Subject: AP1000 COL Standard Technical Report Submittal of APP-GW-GLR-117, Revision 0

APP-GW-GLR-117, Revision 0

“Incorporation of the Maintenance Rule”

Incorporation of the Maintenance Rule

Figure 17.4-1

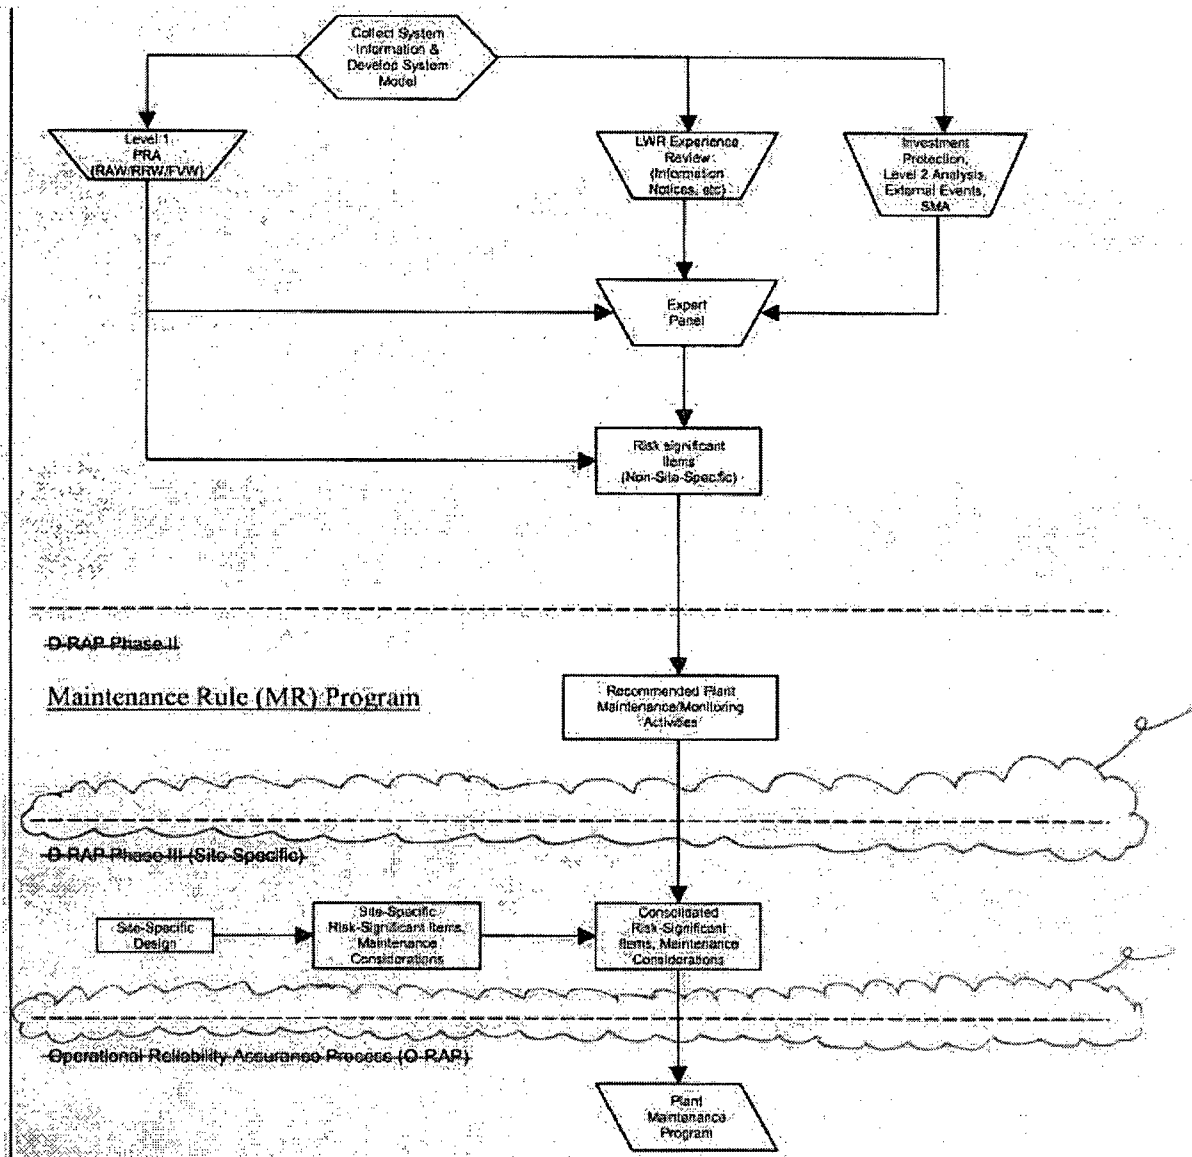
The D-RAP, as shown in Figure 17.4-1, is implemented during in three phases. The first phase, the Design Certification phase, defines the overall structure of the AP1000 D-RAP, and implements those aspects of the program which are applicable to the design process. During this phase, The D-RAP identifies risk-significant SSCs are identified for inclusion in the Maintenance Rule (MR) Program (Reference 10) using probabilistic, deterministic, and other methods.

Finally, Figure 17.4-1 shows The MR Program Operational Reliability Assurance Process (O-RAP). This phase, which is implemented by the Combined License applicant, provides confidence that the operations and maintenance activities performed by the operating plant support should maintain the reliability assumptions made in the plant PRA.

Design Reliability Assurance Program and O-RAP MR Program
